# CONSERVATION COMMISSION AGENDA

Date: April 6, 2021

Updated Site plan for 20 Cedar Lake

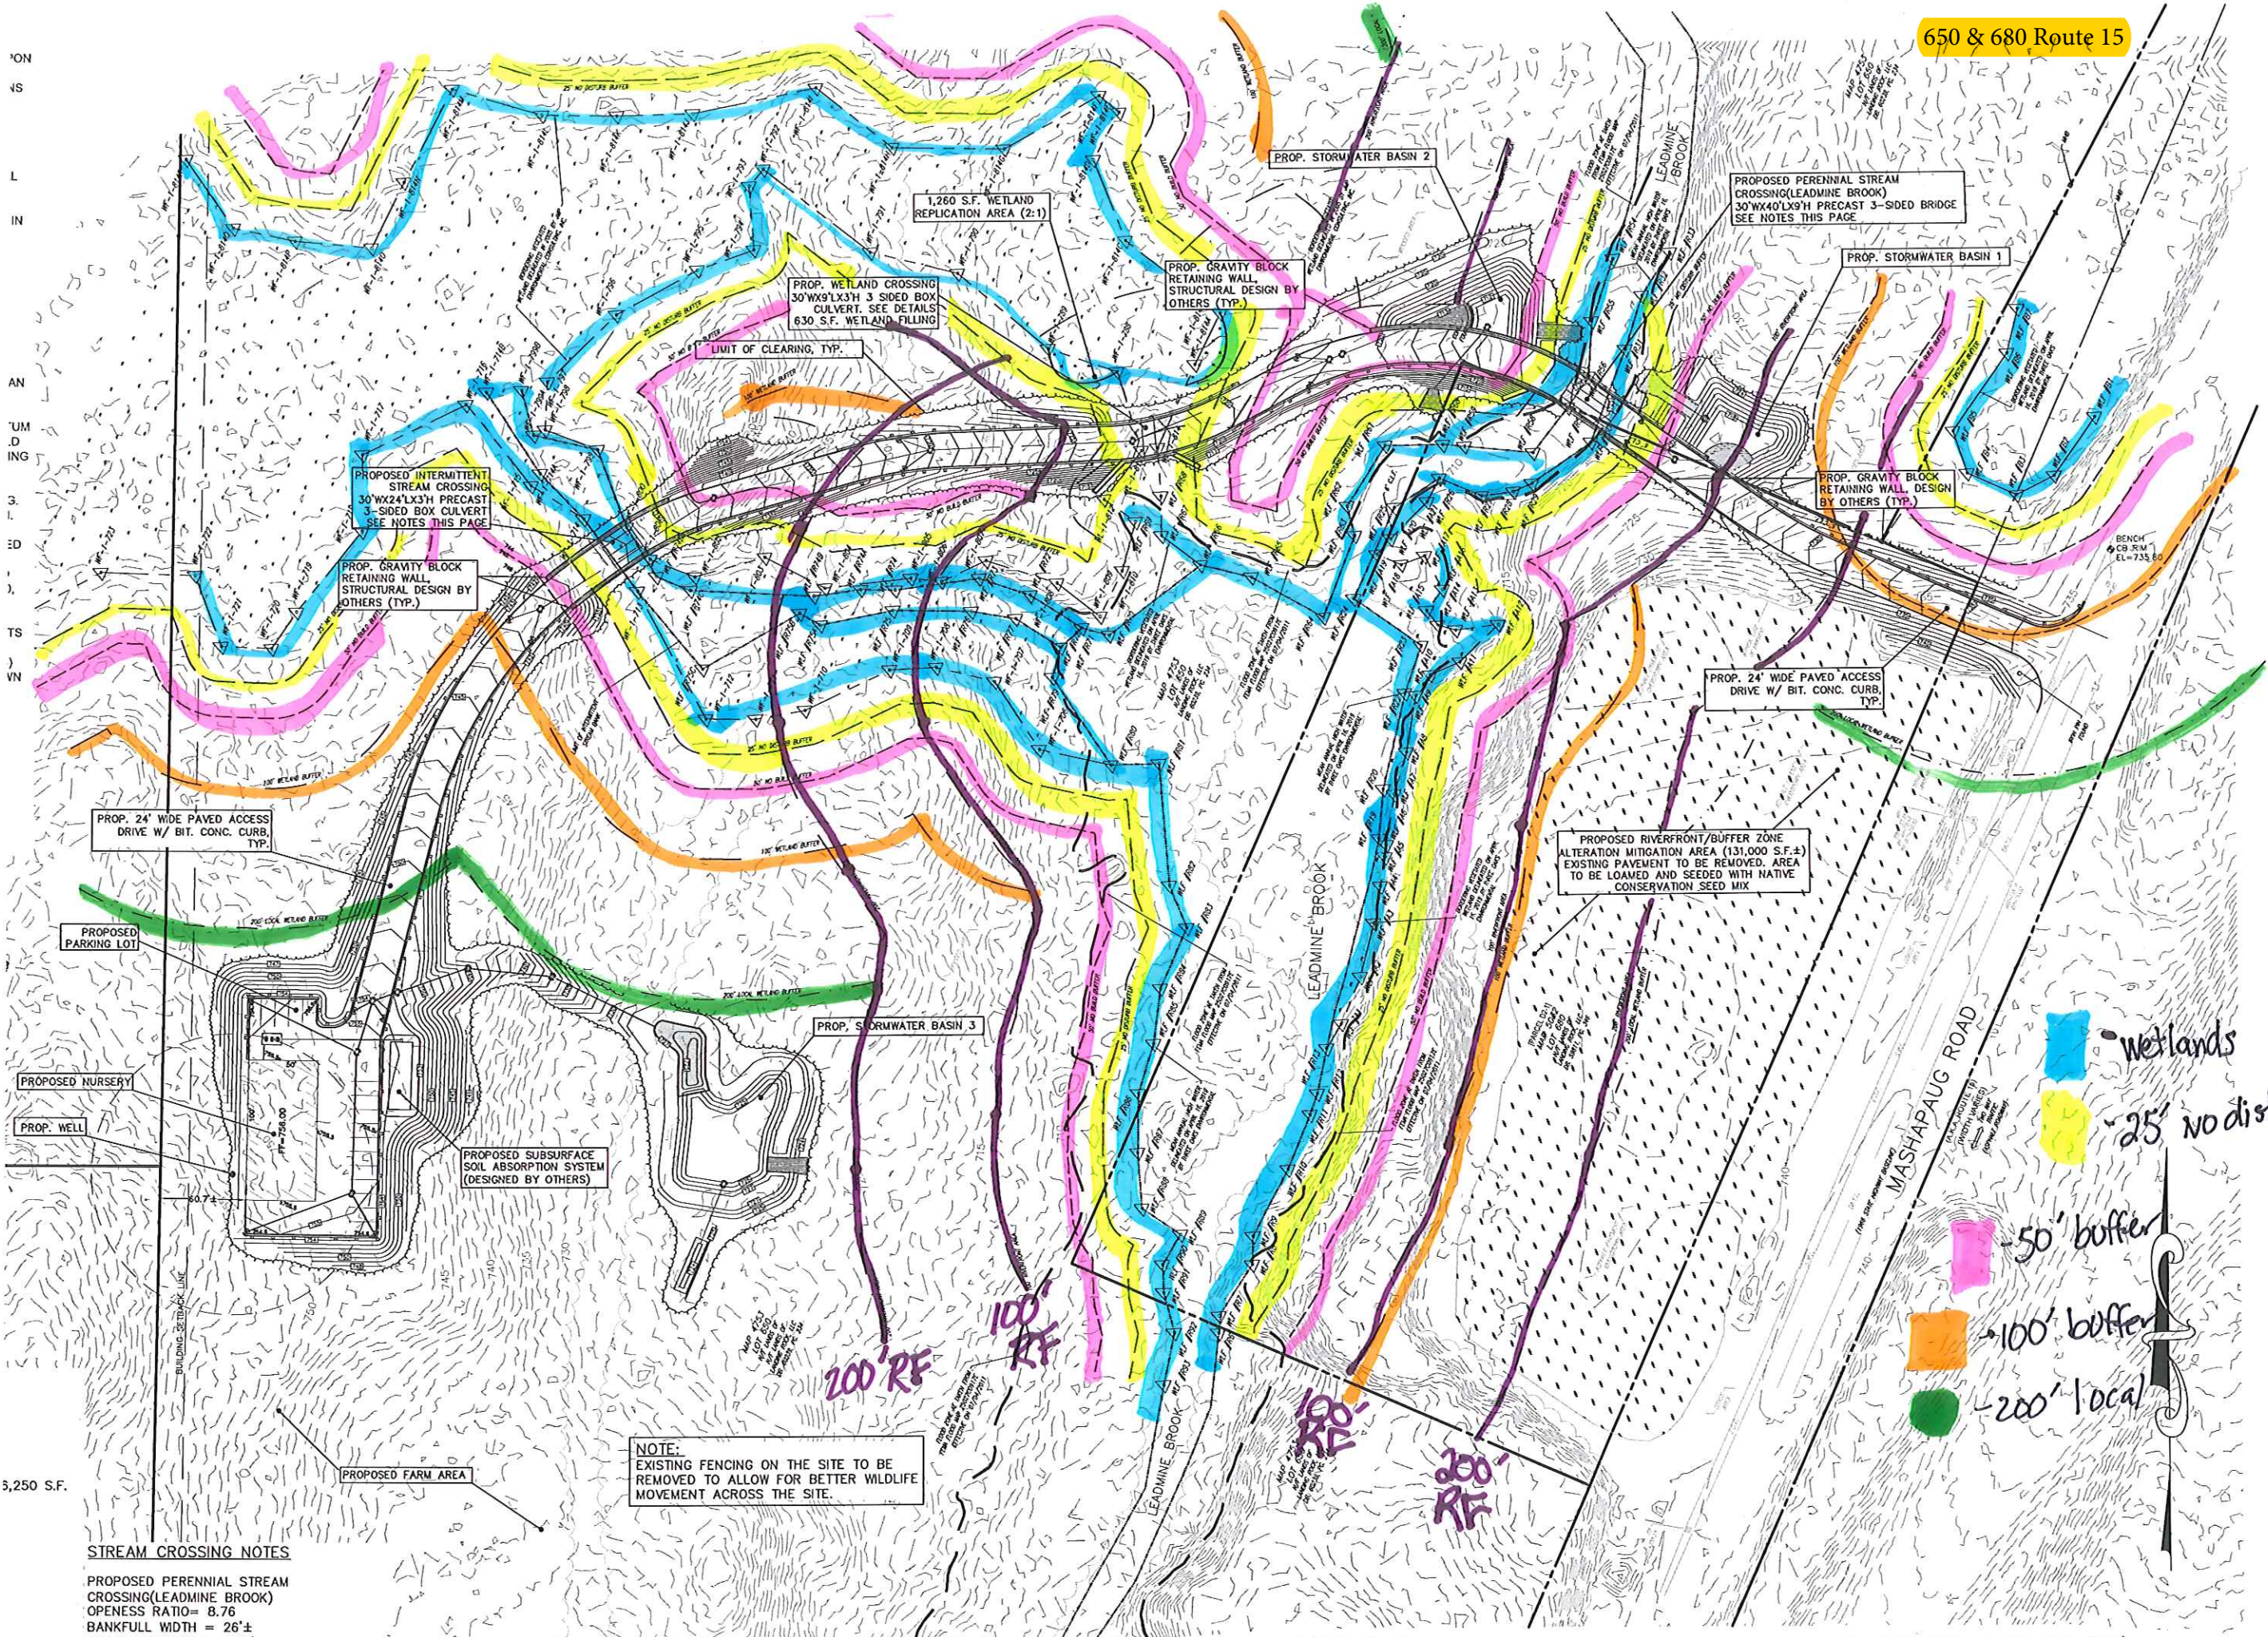
- Staff Notes
  - Staff have discussed revisions with the applicant and representative. Revised plans have been received.
  - House and deck have been removed from the 25 ft buffer zone. Shed will still be located within the 25 ft BZ, however has been moved away from the top of the bank (approx. 5.5 ft). Structure will be located on pilings to not impede flooding capacity of the BLSF. Building code restrictions apply to structures located within flood zones. Shed will have gutters and rain barrel for runoff collection.

- New structure will be located within the 50 ft BZ. However, the increase will only be 114 sq. ft as provided by the engineer. Additional measures have been incorporated to capture roof runoff.

- Project also includes revisions to the shoreline wall. The applicant is proposing a more natural restoration of the shoreline which includes coir logs, coir mats and plantings. Some sections will include a stone base. These are sections which are more subject to wave action and erosion. Toe of slope shall not exceed existing toe of slope. This design would not appear to require a wildlife habitat evaluation and would be an improvement over the existing conditions for wildlife and increase flood capacity.

- Vote to close the hearing and issue an Order of Conditions with the SCC’s standard conditions and the following special conditions:
    1. deck boards include gaps for runoff and that a pea stone or similar material is placed under the deck at a minimum depth to infiltrate runoff (at least 4 in.).

2. Toe of slope shall not exceed existing toe of slope. Existing toe of slope to be documented by P.E. Profile sketch(s) for shoreline work shall be submitted to the SCC with existing conditions and proposed.

3. Qualified landscape contractor to monitor shoreline work (wall and plantings) twice a year (during the growing season) for 2 full growing seasons. Landscape plantings must have a survival rate of 75% of after 2 growing seasons. Reports shall be submitted to the SCC.

<b>CLIENT:</b> RANDY BERCUME 12 ACORN LANE STURBRIDGE, MA	
<b>CONSERVATION COMMISSION PLAN</b>	
<b>SITE ADDRESS:</b> 91 CLARKE ROAD STURBRIDGE, MA	
<b>DRAWN BY:</b> JOD	<b>SCALE:</b> 1"=30'
<b>CK'D BY:</b> JOD	<b>REV #:</b> 0
<b>DATE:</b> 2-15-21	<b>PROJECT #:</b> 21-112
<b>DWG. NO.:</b> C-1

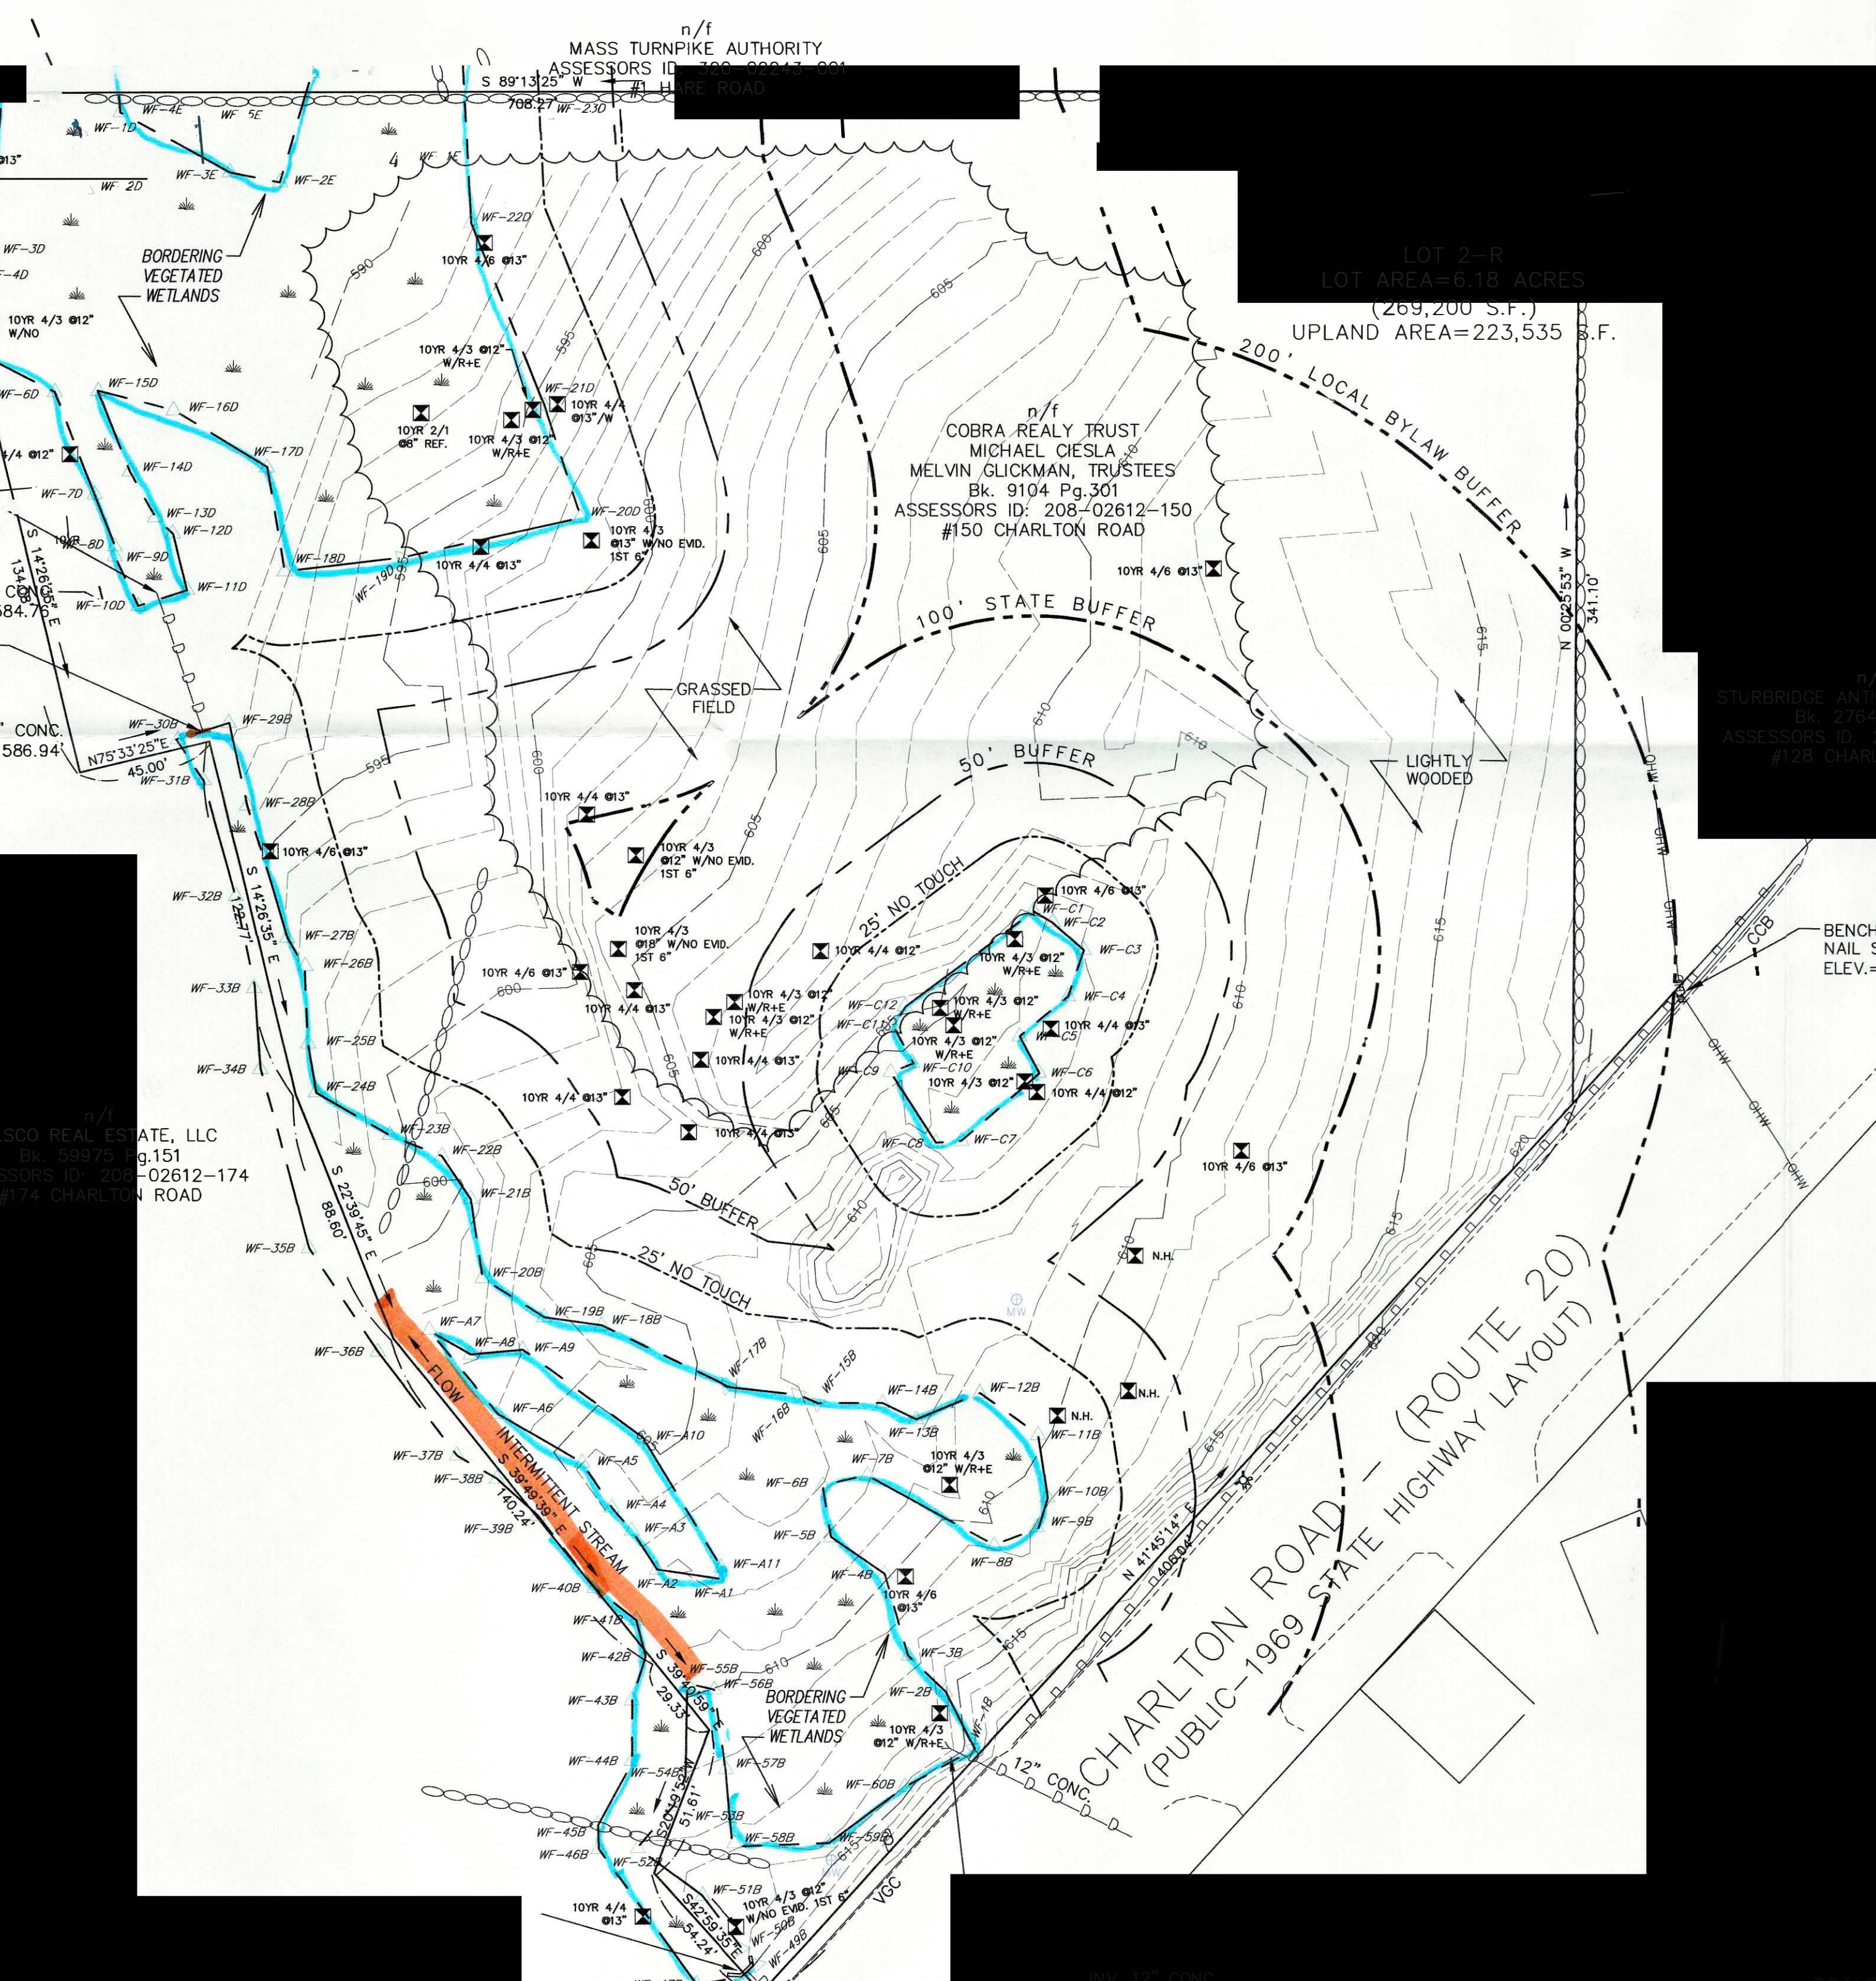
- Staff Notes:
  - Staff and members of the board visited the site on March 23, 2021.
  - There are concerns with the wetland delineation as shown on the plan. The limit of wetlands appears to exceed what is shown on the plan near Clarke road. In addition, the limit of work would therefore be much closer to the wetland edge.

- Staff Recommendations: Staff recommended that the board request additional information pertaining to the wetland delineation and request a continuation to May 4, 2021 for the submission of such information. The wetland was delineated in the winter (1-8-21). The applicant's consultant should review the wetland and submit BVW data sheets to either support the line as shown or to change the line where necessary. If a continuation is not granted, staff recommend that the project is denied for lack of information.
